Subject: MHI's Response to US-APWR DCD RAI No. 880-6142 Revision 0 (SRP 03.11)

Response to Request for Additional Information No. 880-6142
Revision 0

US-APWR Design Certification

RAI NO.: NO. 880-6142 REVISION 0

Figure 2.1 Project EQ Program (PEQP) Implementation Framework

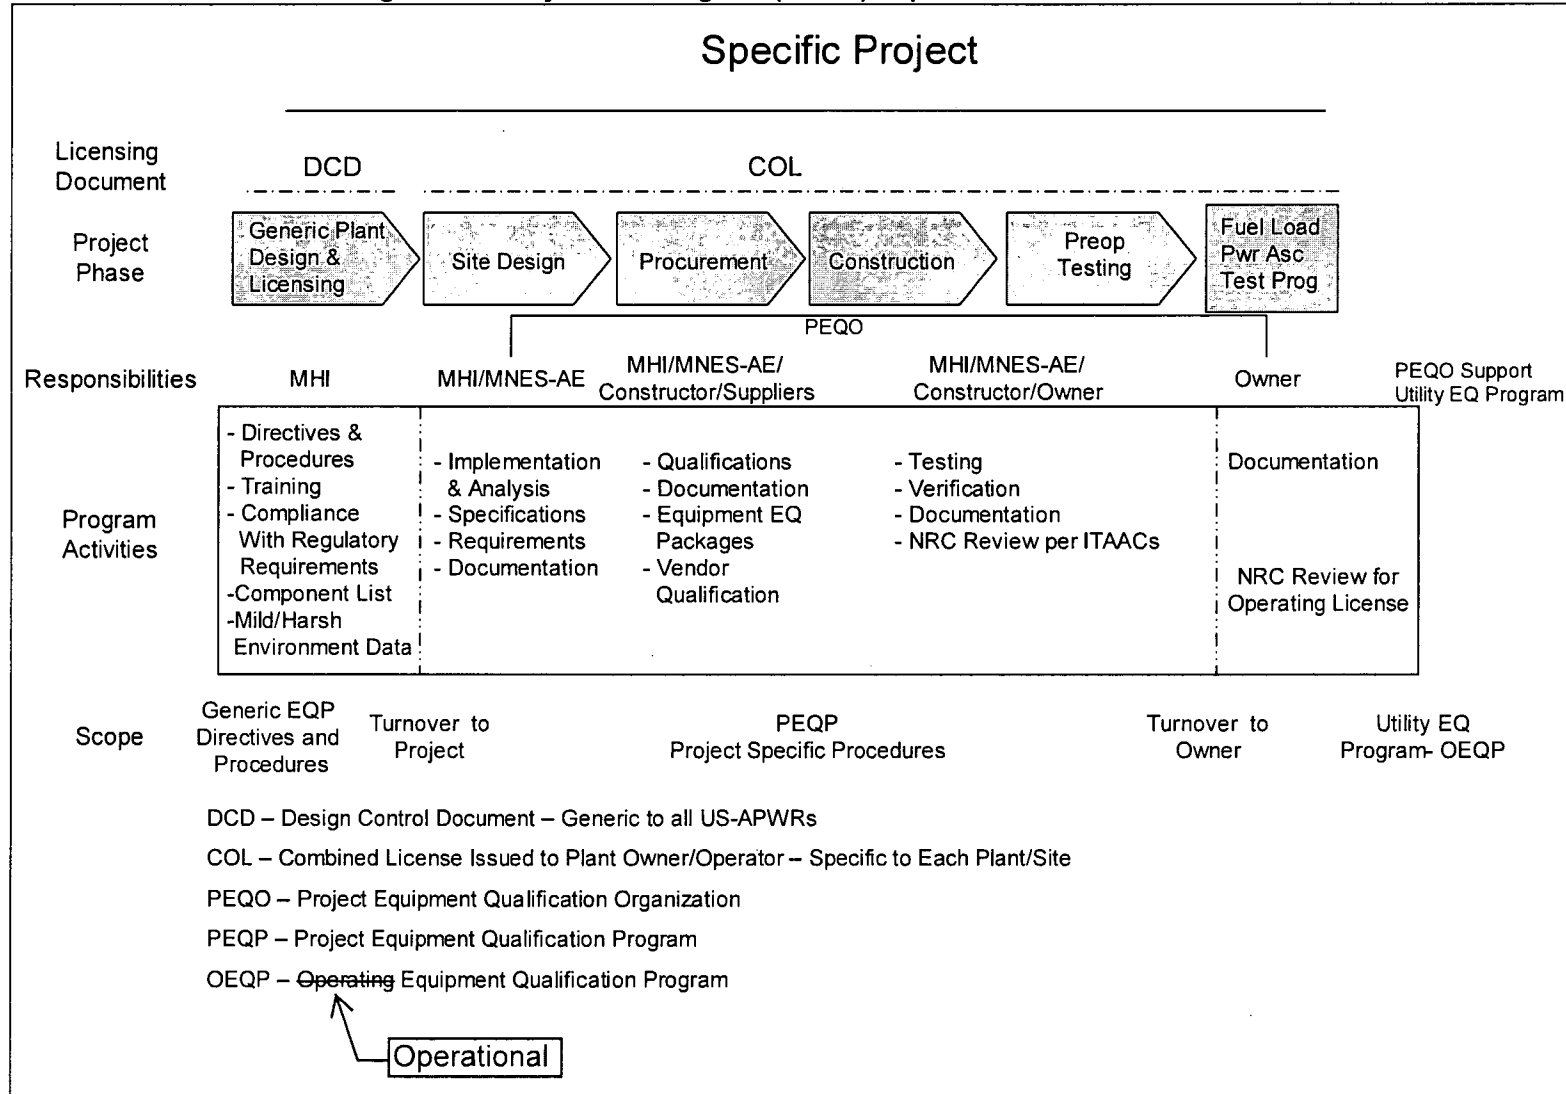
SECY-05-197 directed implementation of operational programs in FSAR Section 13.4 for Environmental Qualification Program for 10 CFR 50.49(a). Section 11.0 (page 97) of Technical Report MUAP-08015 refers as equipment qualification operating program, not operational program. If this is true, this should be corrected throughout the report.

The Operational Equipment Qualification Program (OEQP) is a program implemented by the COL holder (plant licensee) [COL Items 3.11(1), 3.11(2), 3.11(3)] and as such describes the requirement for development of an operational equipment qualification program (OEQP). Technical Report (TR) MUAP-08015 describes the initial Equipment Qualification Program (EQP) used during the design, procurement, construction, testing and initial startup of the US-APWR. The EQP described in TR MUAP-08015 is the EQP required for the US-APWR vendor (design certificate holder). The EQP becomes the basis for the long term OEQP, which is used to operate and maintain the plant SSCs, including their qualification bases for the plant design life. This distinction is described in TR MUAP-08015 in Chapters 10 and 11. For clarification, the "operating" terminology will be revised, as appropriate, to be consistent with the term "operational" during the next revision of MUAP-08015.

Figure 2-1 illustrates the scope of a project-specific EQP. Projects can be divided into phases, and although the distinctions between these phases are in practice not sharp, from a planning or management perspective, they are unique. The DCD process licenses a standardized US-APWR, including the generic EQP. When a plant is sold, an application is normally submitted for a COL that covers the time period associated with site-specific design, procurement, construction and startup phases of the project. Site design phase in COL also includes development of site-specific environmental data that is used to verify the standard design, and evaluate site-specific portions of the plant, including input design parameters for EQ. Prior to and during the initial power ascension testing, the COL transitions to a full Operating License (OL). The PEQP covers the time period and phases associated with the COL up to the point when a full OL is authorized. At the point that the plant is complete, and the project transitions to the owner and the PEQP transitions to the owner's (plant licensee's) EQP. The licensee's EQP is an operating program primarily designed to assure qualified replacement parts are used during the life of the plant. The PEQP is a design, procure, construct and test EQP. Thus, for each US-APWR, there are three applicable and distinct EQPs. They are:

1. **Generic Equipment Qualification Program (EQP):** The program that provides the foundation for the project-specific EQP. This program and the associated commitments to the NRC are addressed in the DCD and in this Technical Report.
2. **Project Equipment Qualification Program (PEQP):** An EQP that is implemented under, and governed by, the MHI/MNES EQ Directives and Procedures for a specific project. A PEQP generates and maintains EQ records in accordance with established project program procedures and quality assurance requirements. This program is implemented under a COL (or associated limited work authorizations). That is, it is implemented when a project transitions from the early licensing phase to the actual implementation phase.

3. **Licensee's Operating Equipment Qualification Program (OEQP):** The plant owner's long-term ~~operating~~ EQP. The OEQP is based on the records and results of the PEQP. The transition from the PEQP to OEQP occurs at the time of initial plant licensure (OL or as a condition of licensure, e.g. at or before fuel load). The plant EQ Program covers the life of the plant (~60 yrs) and is discussed in the licensee's COL application (Ch 13 of the COL). Operational
